# TECHNICAL NOTE

**Project Code:** 301401183      **Project Name:** Hillarys Beach Club

**SUBJECT:** Traffic Assessment

Hospitality Total Services (Aus) Pty Ltd on behalf of Sandgate (WA) Pty Ltd have engaged GTA, now Stantec (Stantec), to undertake a peer review of the internally prepared "Traffic Impact Assessment for Medium Impact Tenancy" for the proposed Hillarys Beach Club at Lot 20, John Wilkie Tarn, Pinnaroo Point, Hillarys.

Figure 4: HTS Proposed Vehicle Paths

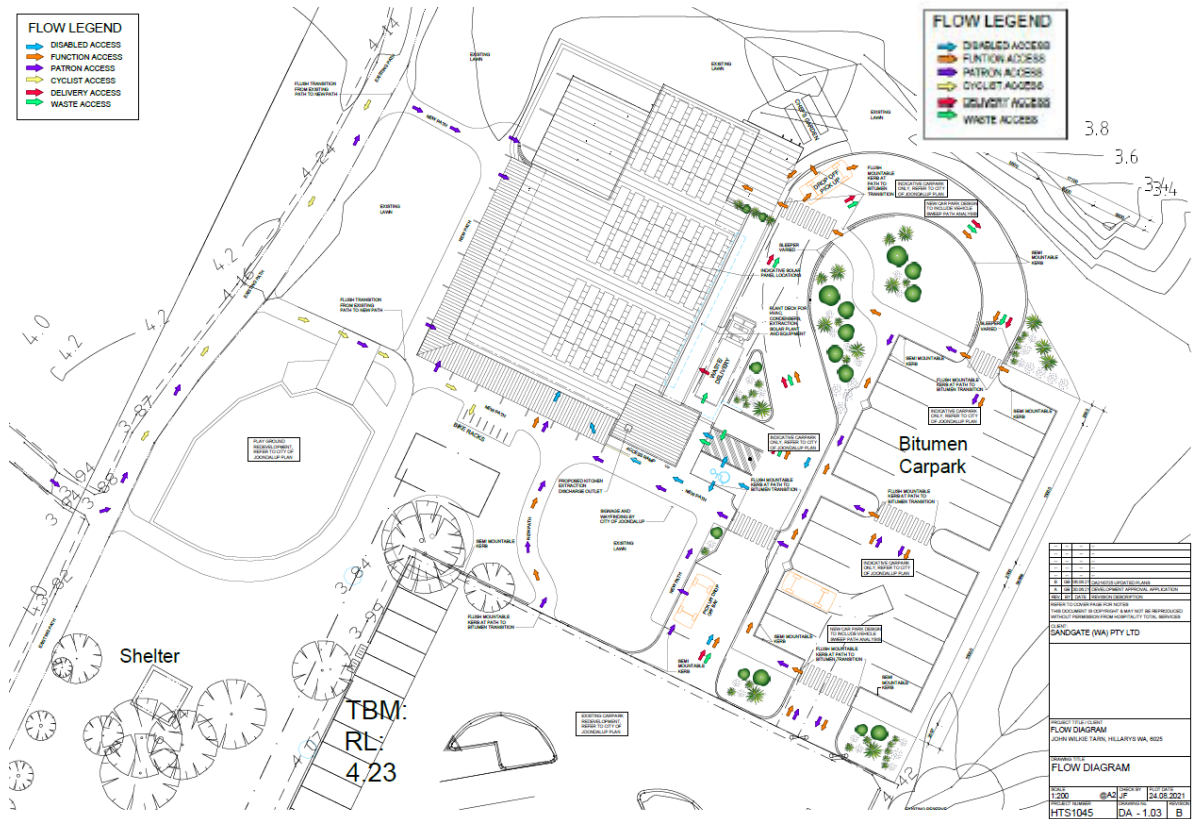
Swept path analysis should be provided for:

- Passenger B85 vehicles for any constrained car parking spaces
- Passenger B99 vehicles for all circulation and parking aisles
- Nominated waste collection vehicle
- Design service vehicle

Ensure that site servicing vehicle movements can occur simultaneously with passenger vehicle movements as the proposed service times may coincide. This should be confirmed with swept paths.

No dimensioned plans of the car park area are provided and as such, a review against the relevant Council policies and Australian Standards can not be undertaken. It is understood that the City of Joondalup has prepared the reconfigured car park layout and as such, it is considered that the necessary design checks will have been undertaken.

The length of the car parking aisles may warrant the installation of traffic calming devices such as speed humps.

Consideration could be given to the installation of concrete island extensions partway through the parking row to help reduce the likelihood of anti-social/hoon behaviour.
